SUMMER - UNIT 1

ATTACHMENT 2

RCS FLOW RATE LESS THAN THERMAL DESIGN (TD) FLOW

Figure 2.1-1
Reactor Core Safety Limit - Three Loops in Operation

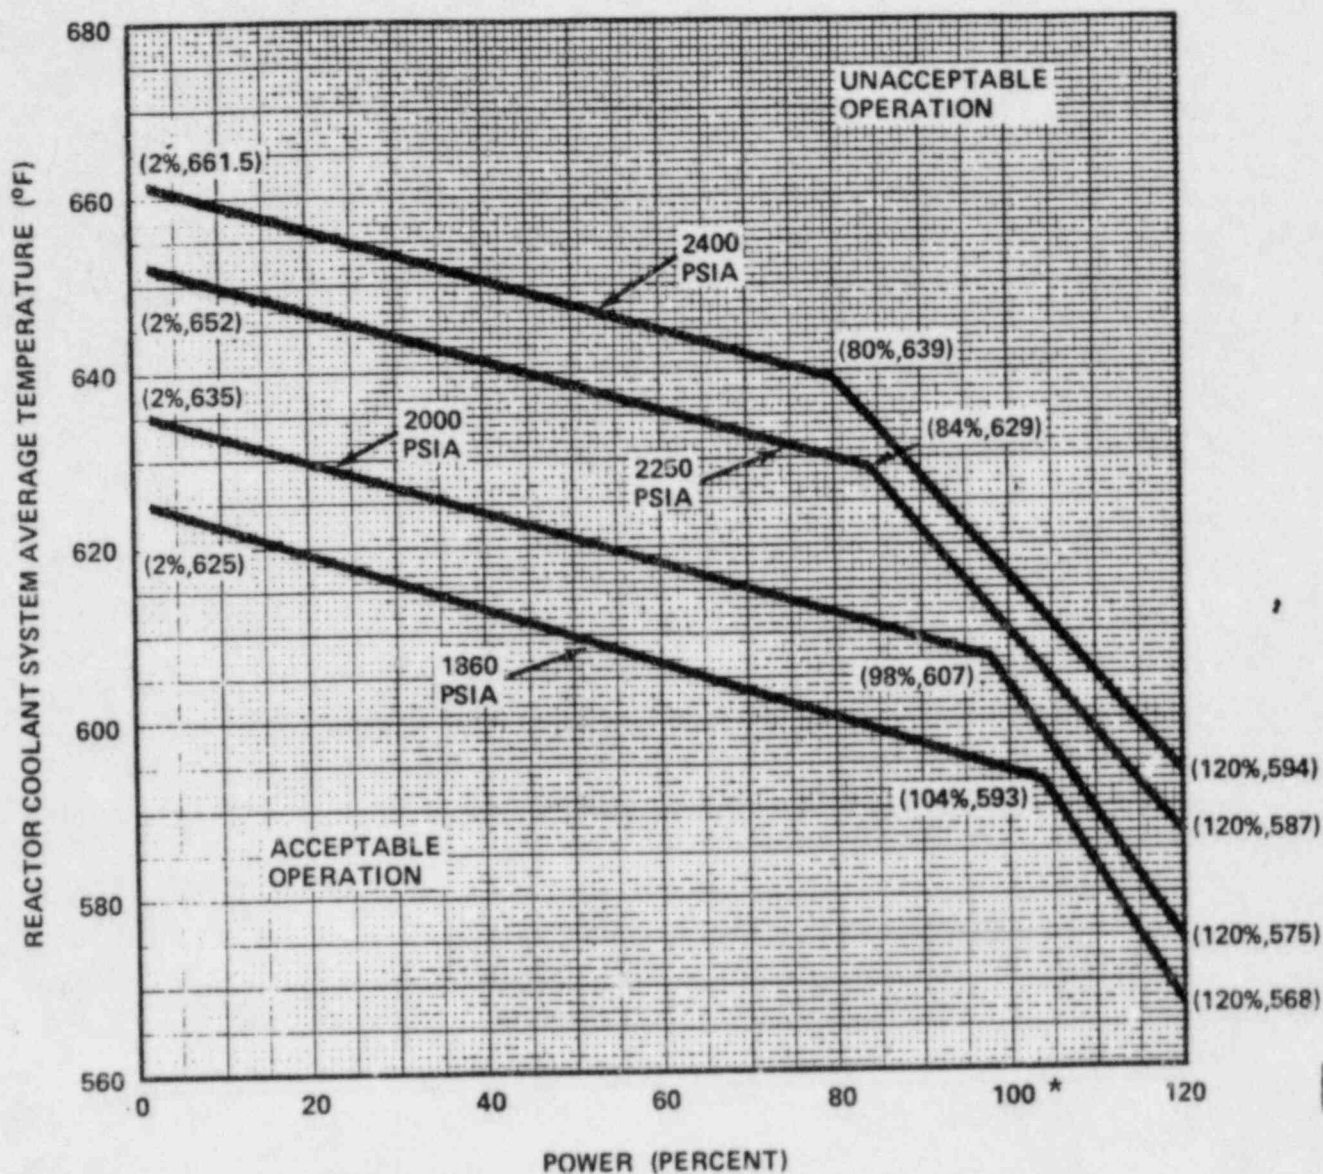
NOTE: When operating in Region III, the restricted power levels shall be considered to be 100% of Rated Thermal Power (RTP) for Figure 2.1-1.

* When operating in Region III of Technical Specification 3.2.3 (Figure 3.2-3), the restricted power level must be considered 100% RTP for this figure.
